Jordan Springs Village 5  
Residential Subdivision  
Concept Design Road Safety  
Audit

### Concept Design Road Safety Audit

Issue: A 25/06/14

Client: Maryland Development Group  
Reference: 12S1267310  
GTA Consultants Office: NSW

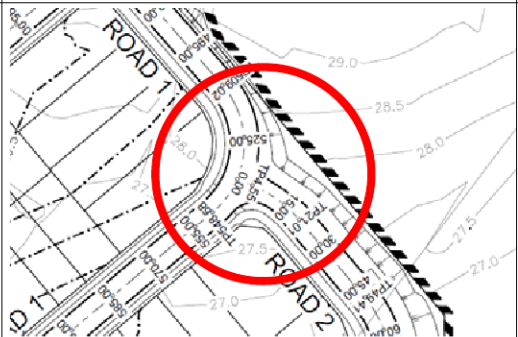
No.	Description	Classification	Figure	Likelihood	Severity	Risk Rating	Designer's Response	Penrith City Council (accepted/rejected)
1	The plans indicate that the northern and southern legs of the proposed eastern road will be offset. This may cause motorist confusion regarding which approach has priority, resulting in a side impact collision.	Road Alignment		Improbable	Moderate	Low	Road No 1 to have priority 'Give Way' signage and line marking at detail design.

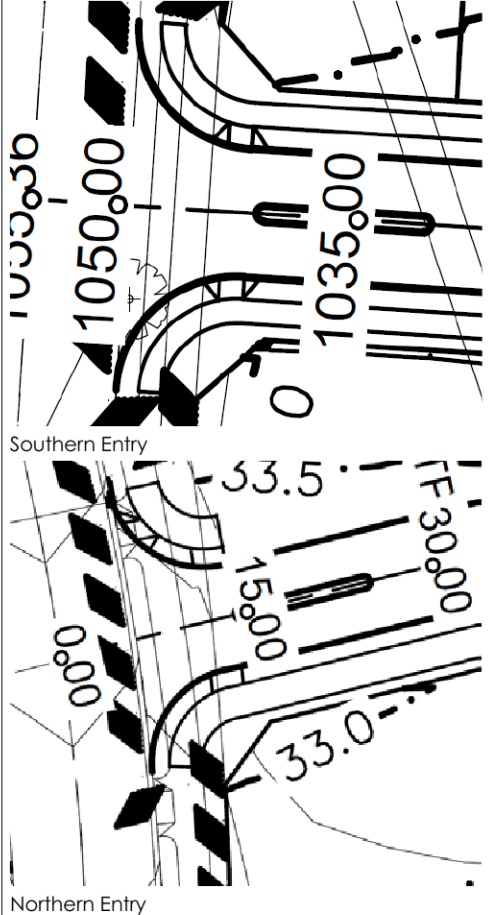
No.	Description	Classification	Figure	Likelihood	Severity	Risk Rating	Designer's Response	Penrith City Council (accepted/rejected)
2	A median island stop sign treatment is provided at the intersections of Greenwood Parkway and Road 1. However, there does not appear sufficient road geometry to accommodate a 12.5m heavy rigid vehicle turning left from Greenwood Parkway into Road 1. Consequently, a 12.5m heavy rigid vehicle may need to reverse to complete its turning manoeuvre which is an unsafe manoeuvre in a pedestrian environment.	Traffic Management Devices	 <p>Southern Entry</p> <p>Northern Entry</p>	Improbable	Moderate	Low	<p>12.5m truck can exit. No allowance for entry.</p> <p>An 8.8m service vehicle has been allowed for in all directions.</p> <p>Geometry has been amended. 12.5m truck allowance for entry and exit movements (Council request for this intersection).</p>

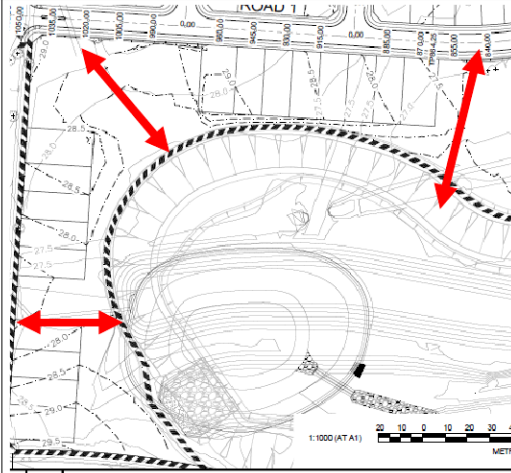
No.	Description	Classification	Figure	Likelihood	Severity	Risk Rating	Designer's Response	Penrith City Council (accepted/rejected)
3	The plans indicate that Road 1 will not have any traffic calming devices. Since the geometry of this road is long and relatively straight, motorists may be inclined to travel at a greater speed than the restricted speed limit through the area. This may cause an incident to occur with another vehicle or a pedestrian.	Road Alignment, Traffic Management Devices		Occasional	Moderate	Medium	Intersection with Road No 5 to include a paved or different pavement finish.	
4	The proposed pedestrian footpath on the eastern road verge (corner of Road No 2 and Road No 8) does not continue in either direction. This may encourage pedestrians to walk along the eastern road verge, increasing the likelihood of tripping or falling.	Pedestrian Infrastructure		Improbable	Minor	Low	Footpath/ramps cross both roads. Look out area proposed immediately adjacent (east)

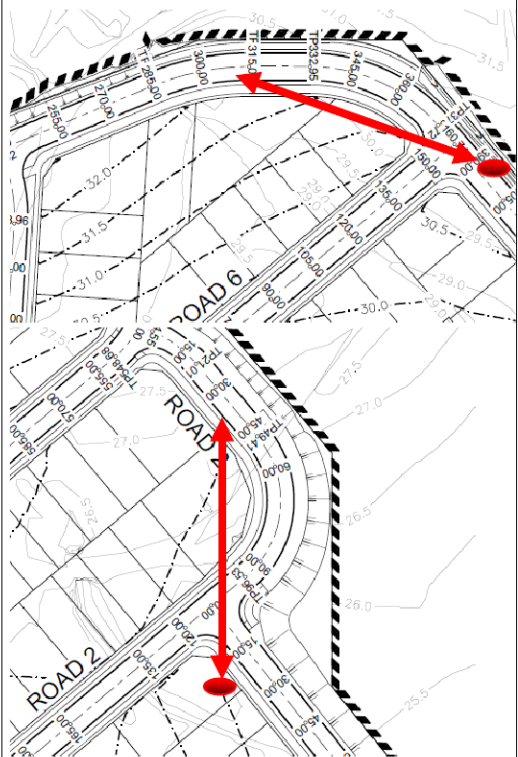
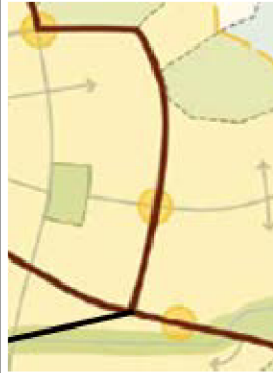
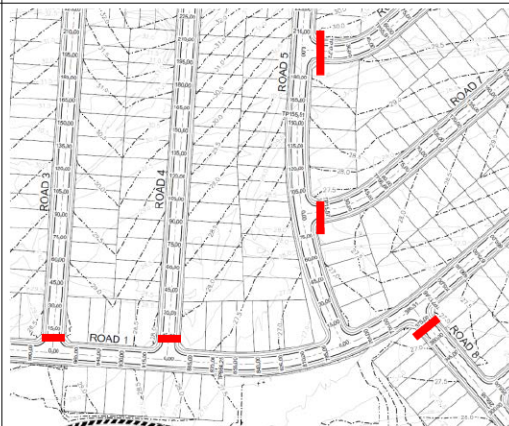
No.	Description	Classification	Figure	Likelihood	Severity	Risk Rating	Designer's Response	Penrith City Council (accepted/rejected)
5	The footpath on the south-western side of Road 8 ends at the pedestrian crossing. There is likely to be a pedestrian desire line between residential houses to the east of Village 5 and East Lake. Pedestrians may attempt to cross the batter (between the Road 8 footpath and the East Lake footpath) which would increase the likelihood of pedestrians tripping or falling.	Pedestrian Infrastructure		Improbable	Minor	Low	Plans/Layout amended

No.	Description	Classification	Figure	Likelihood	Severity	Risk Rating	Designer's Response	Penrith City Council (accepted/rejected)
6	The shared path on the north side of Road 8 ends at the pedestrian crossing. Consequently, cyclists may continue west on the footpath which may lead to conflict with pedestrians. Furthermore, cyclists may cross onto the westbound travel lane whilst cycling which may lead to conflict with vehicles, particularly given the upstream 'blind' corner.	Cycling Infrastructure		Improbable	Moderate	Low	'End Shared Path' treatment to be added at detailed design. Share path continues south west to lake.	
7	It appears as though the future East Lake will have a pedestrian footpath around the perimeter of the Lake. There appears to be a lack of pedestrian footpath connections between the Lake and adjoining footpath. The gradient of the parkland surrounding the park is unclear. Without any pedestrian facilities connecting footpath surrounding the lake and road network footpath pedestrians may trip and fall.	Pedestrian Infrastructure		Improbable	Moderate	Low	Pedestrian connectivity provided at east and west edges of lake. Additional connectivity to be addresses as part of future lake DA
